Section 4.55(1A) Modification Application
to SSD 8209-
Site 4A, Oakdale South Industrial Estate,
Kemps Creek

Statement of Environmental Effects
Site 4A, Oakdale South Industrial Estate, Kemps Creek

Project Name _____ **Costco Mod 1**

Figure 6 – Annotated A1 – A5 and clouded changes.

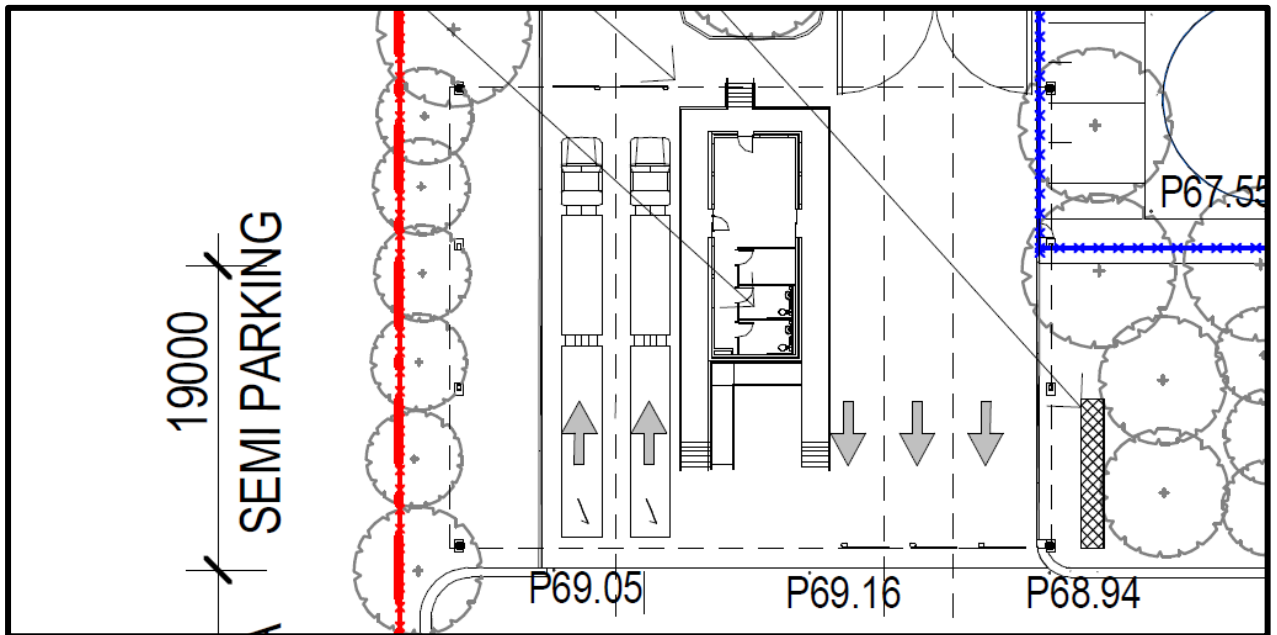
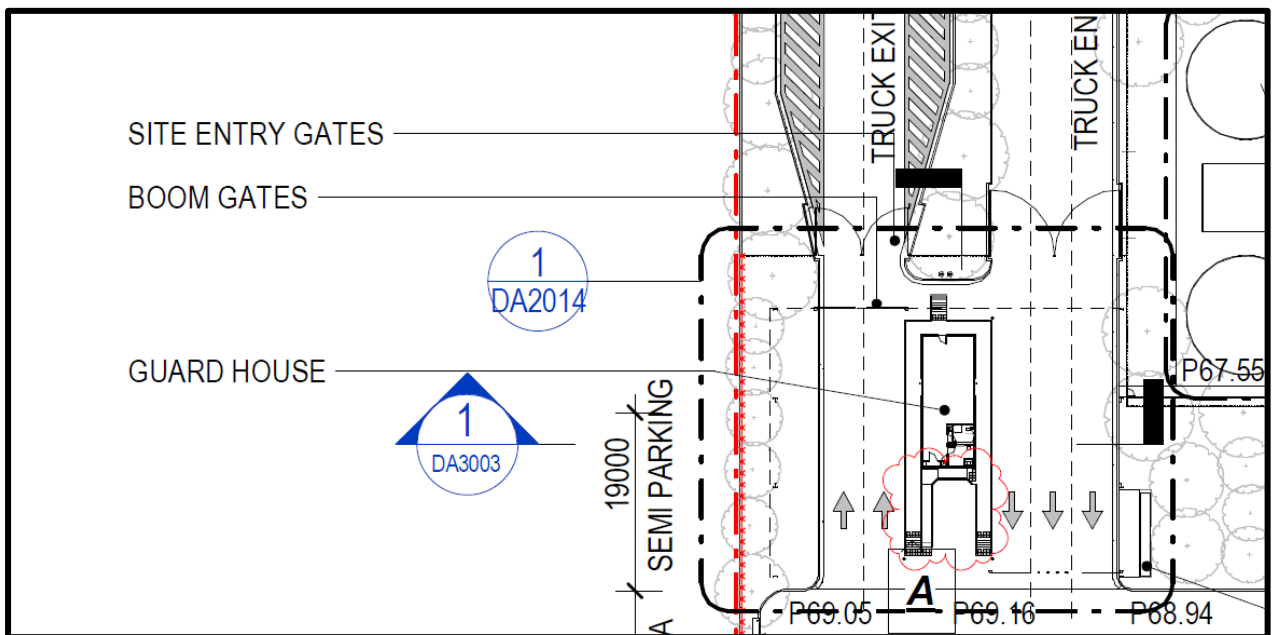
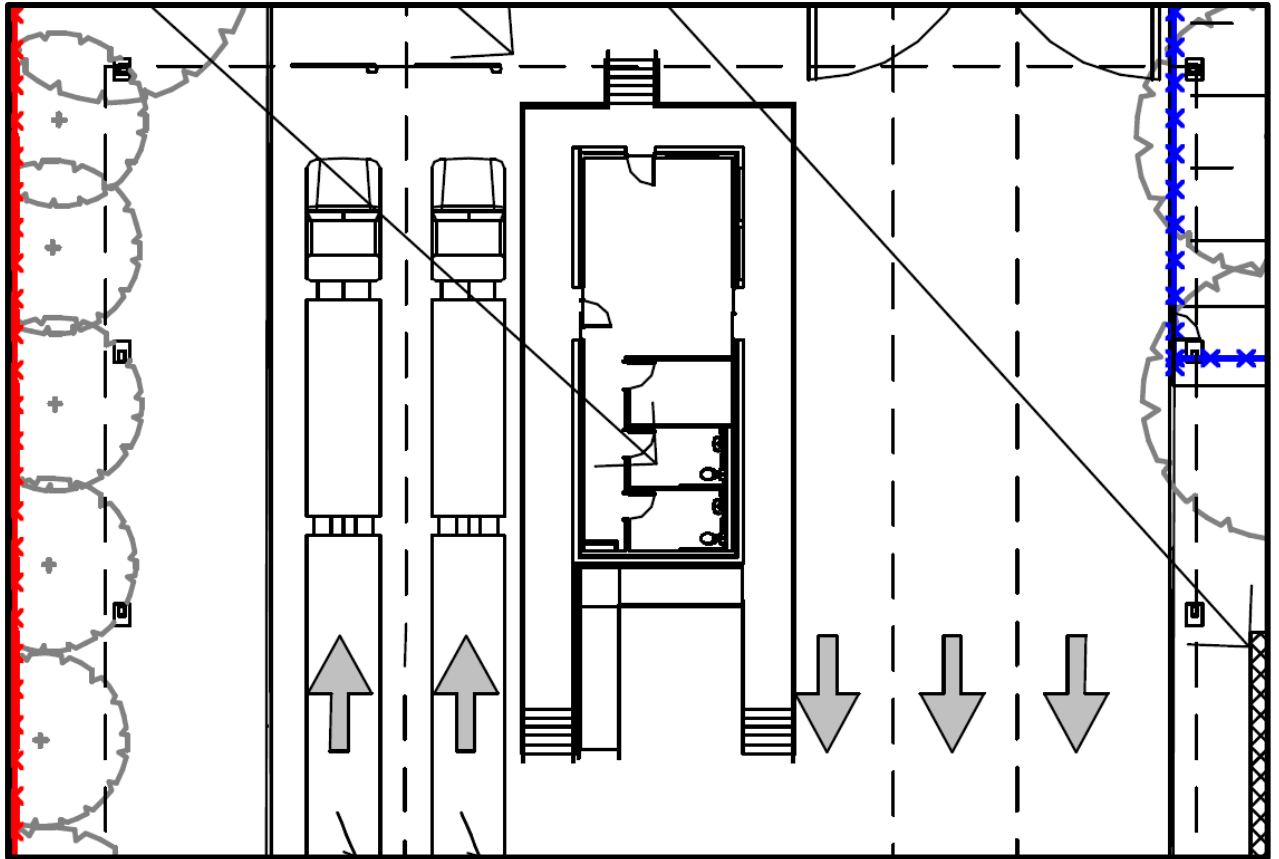
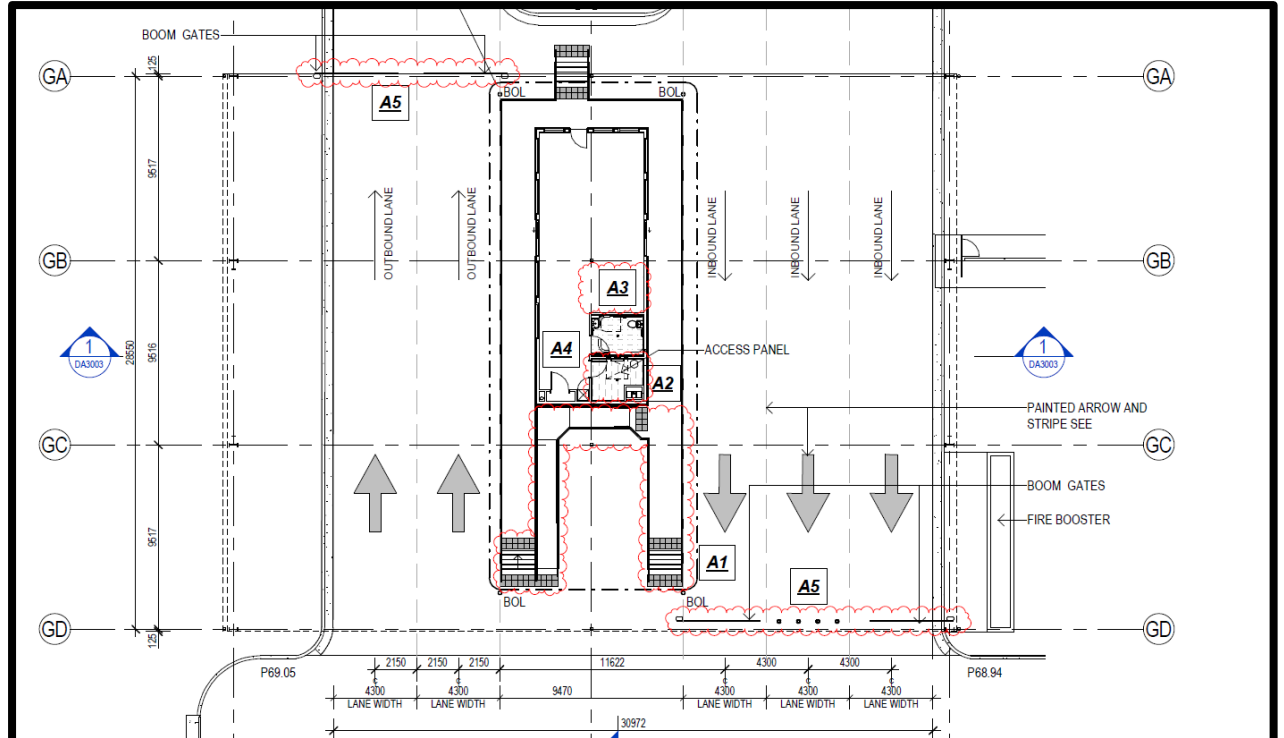
Modification of Guard House Access Ramp and internal layout located near the south west corner of the site. Refer to details as referenced as **(A)** on Architectural plans. Specifically, those changes include:

- i. extension to ramp and stairs by 2m **(A1)**;
- ii. deletion of second accessible toilet **(A2)**;
- iii. relocation of cleaner/janitor's room to previous location of accessible toilet **(A3)**;
- iv. provision of electrical and comms cupboard added adjoined to relocated cleaners/janitors **(A4)**;
- v. Relocation of boom gates **(A5)**.

Figure 8: Proposed changes to Structural grid located outside the wet storage cross dock area, notated and clouded in red.

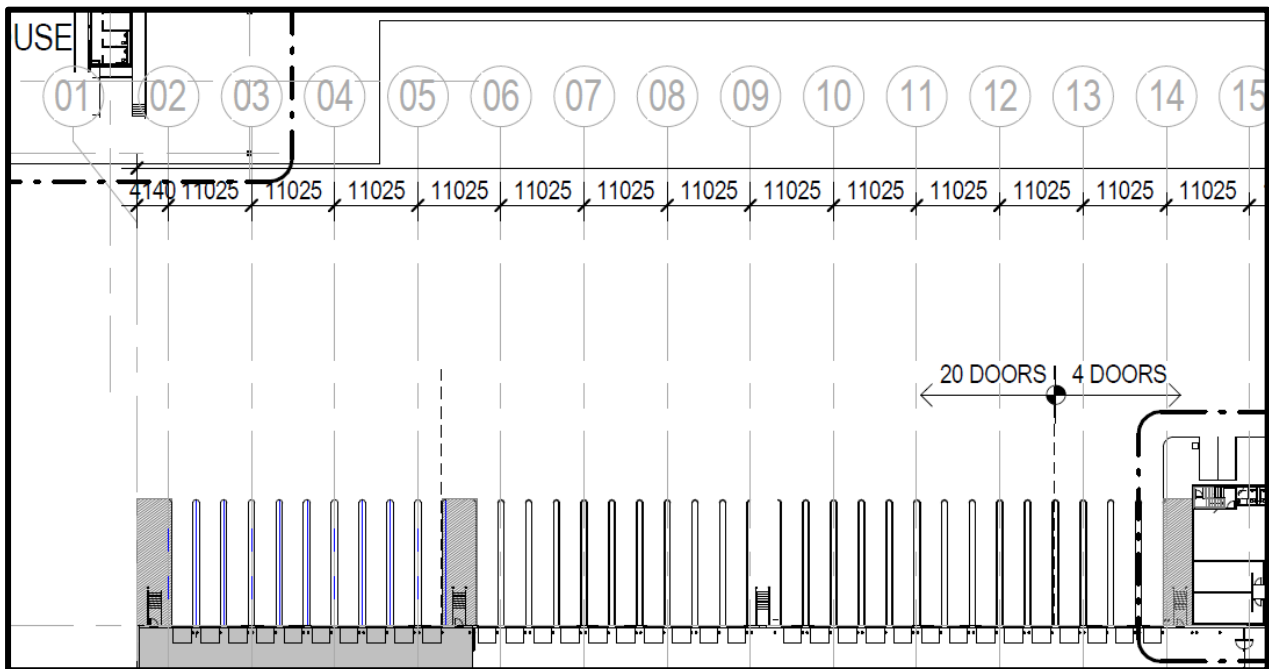
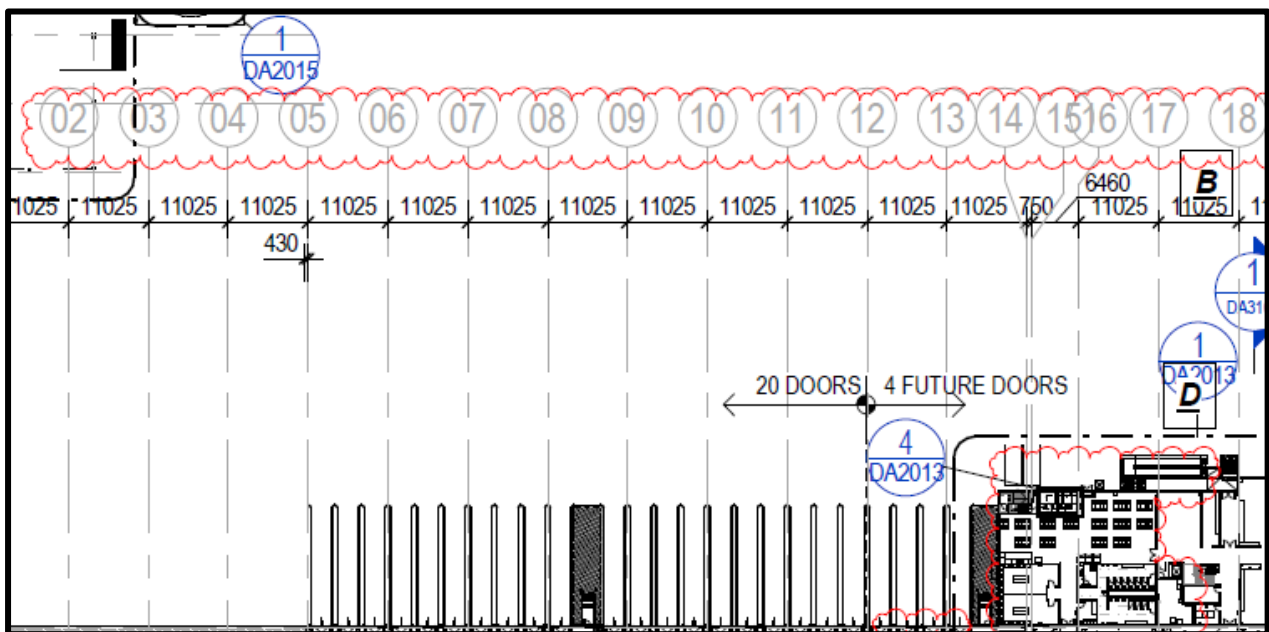
Minor changes to the structural grid wet storage cross dock layout as referenced as **(B)** on architectural plans;

Figure 12: Proposed changes to precast panels/ bonded dock doors and dock door canopy, notated and clouded in red.

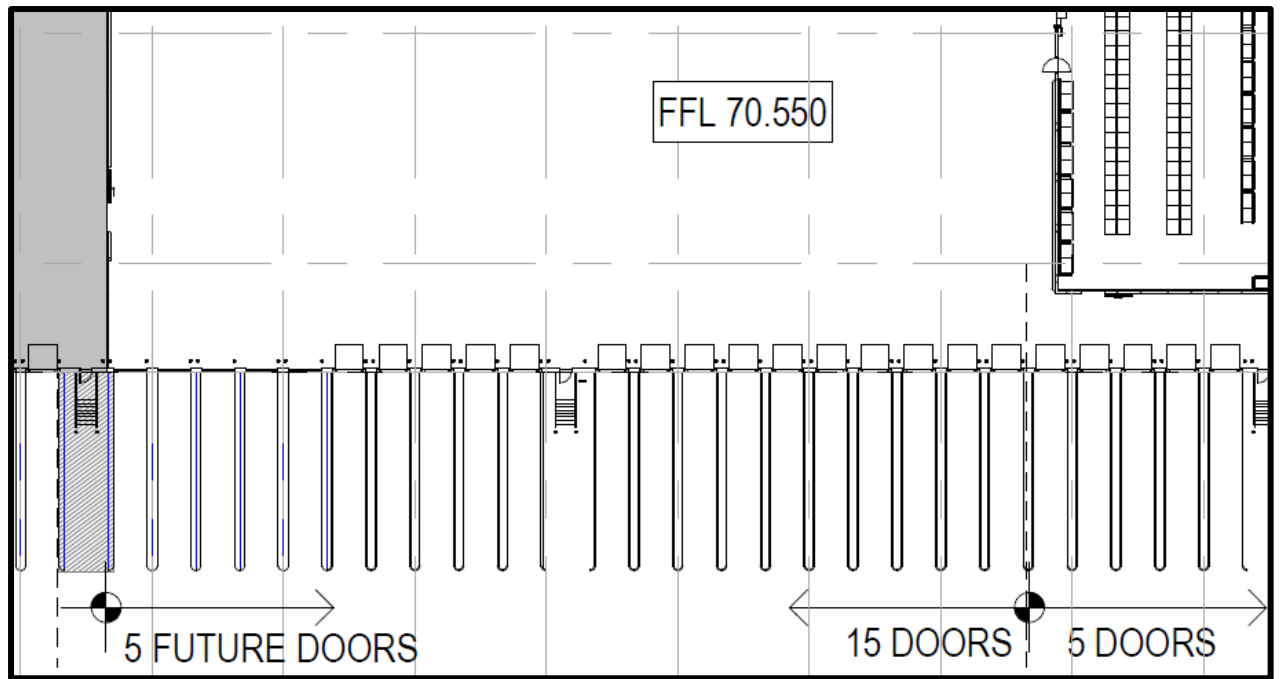
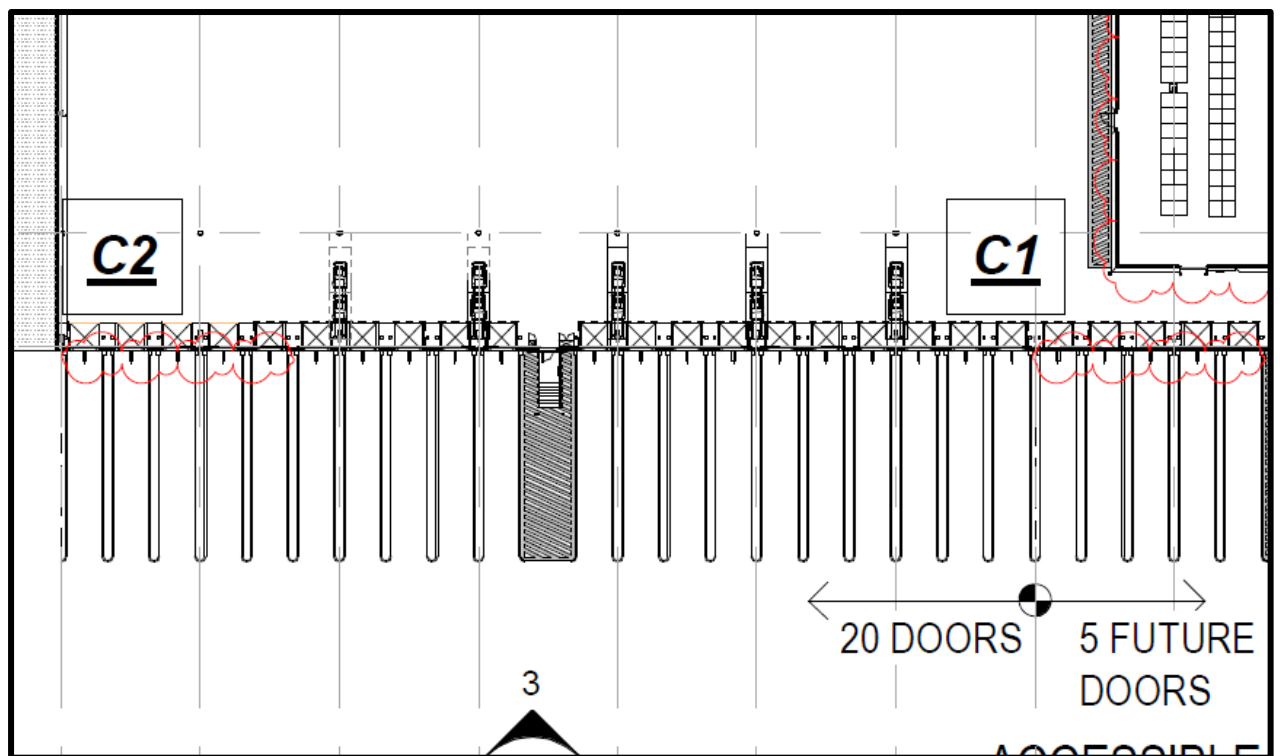
Changes to bonded dock doors locations and timing as referenced as **(C)** in architectural plans.

- i. Bonded dock doors changed to Future knock out in precast panels as referenced as **(C1)**;
- ii. Future knock-out in precast panels changed to bonded dock doors as referenced as **(C2)**;
- iii. Extension of Dock door canopy across all shipping and receiving doors as referenced as **(C3)**.
